CIRCULATE TO:-		
SERVICE MGR.	X	
RECEPTION	X	
WORKSHOP	X	
PARTS	X	SUBJECT Poor Start or Non Start Related To Ignition Module Failure
MODEL	AFFECTED VEHICLES Range Rover LH 464554 to LH 651319-Discovery LJ 081991 to LJ 094035-Defender from LD 917122	
Range Rover Discovery/Defender		02/09/94 86/08/94/US

SUBJECT **Poor Start or Non Start
Related To Ignition Module Failure**

FIG 1

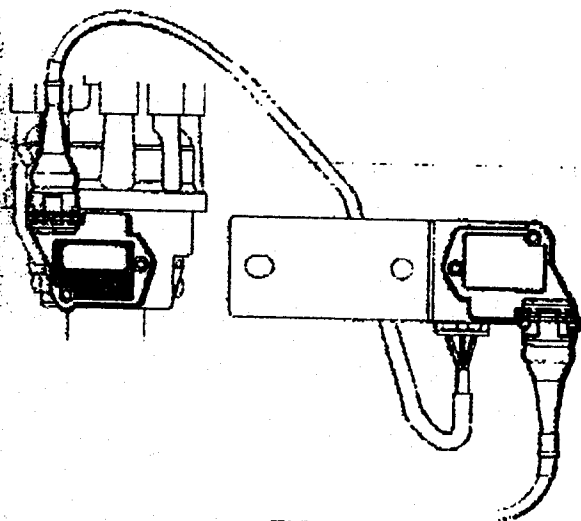
5) With the distributor correctly fitted, place the heatsink bracket assembly on the wing near the ignition coil. Connect the Econoseal connector of the service pick-up lead to the Econoseal connector attached to the heatsink bracket. (See fig 1)

6) Feed the 3-pin mini timer connector end of the lead under the front of the air cleaner housing and connect to the dummy module on the distributor. (See fig 1)

FIG 2

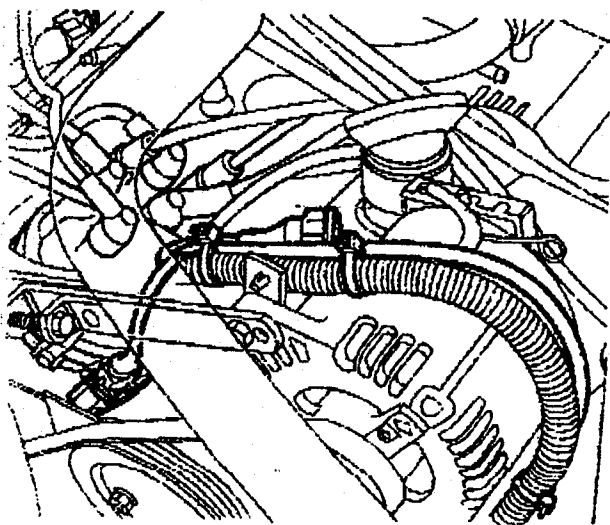
7) Cable-clip/tie wrap original engine harness connector back onto the harness. (See fig 2)

12) Cable tie the service pick-up lead to the engine harness. (See fig 2).

FIG 3

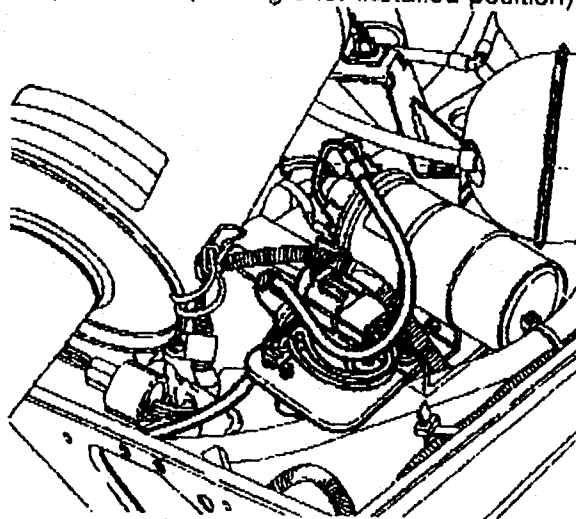
11) Fit the heatsink bracket beneath the coil. Re-mount the coil and heatsink bracket to the inner wing. Connect the two connectors of the fly lead to the ignition coil. (See fig 3 for installed position).
